Rancho Santa Fe Association

Staff Report – Board of Directors Information

Item: Grading Regulation (Working Draft)

CHAPTER 41 SLOPE PROTECTION REGULATION FOR GRADING AND BUILDING PERMIT APPLICATIONS

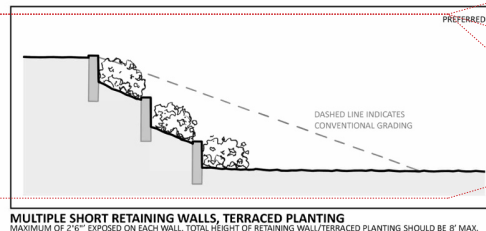
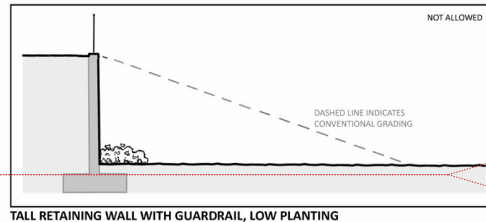
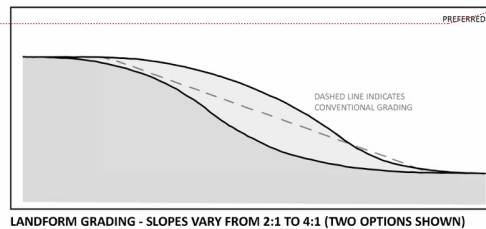
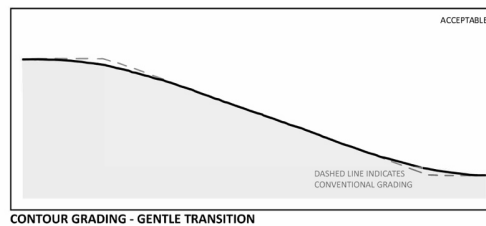
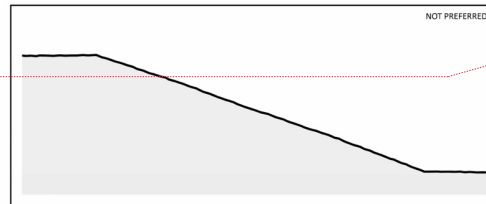
41.0303 Slopes Less Than 25%. For any area of the site that contains a slope that is less than 25%, it is desired to have buildings integrate with the natural features of the site by way of stepping the proposed buildings with the site, minimizing Grading, restricting retaining walls to less than four-feet (4 vertical) and/or using terraced walls (if Grading requires it) are also limited to a combined limit of 8' of cut or fill. Buildings shall generally be located on flatter topography. Limited cut slopes are preferred to fill. If limited Grading is proposed, Contour Grading and/or Landform Grading shall be used and limited height retaining walls shall be considered.

Grading and placement of buildings on slopes less than 25% shall only be approved if:

(a) The proposal is integrated with the natural landscape features of the site in an aesthetically pleasing manner by minimizing Grading, retaining walls and visual prominence.
